Product Change Notice (PCN)

PCN Number: **PCN-0451147R-01**

Product(s) Affected: **PJ-036D & PJ-036DH**

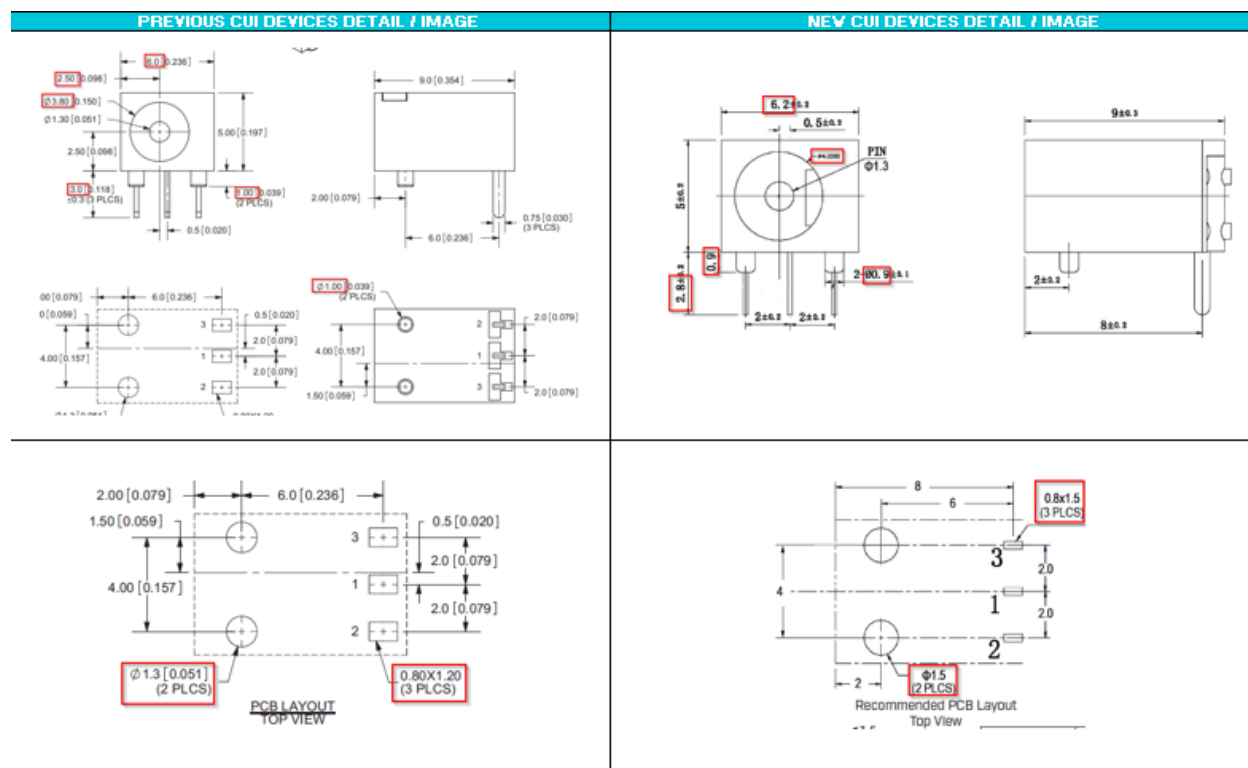
Description of Change: **Mechanical, electrical, and material changes as shown below:**

MATERIAL	PLATING
center pin	brass	silver
terminal 1	brass	silver
terminal 2	copper alloy	silver
terminal 3	brass	silver
plastic	PA66

DESCRIPTION	MATERIAL	PLATING/COLOR
center pin	brass	silver
terminal 1	brass t=0.25	silver
terminal 2	brass t=0.25	silver
terminal 3	brass t=0.25	silver
housing	PBT (UL94V-0)	black
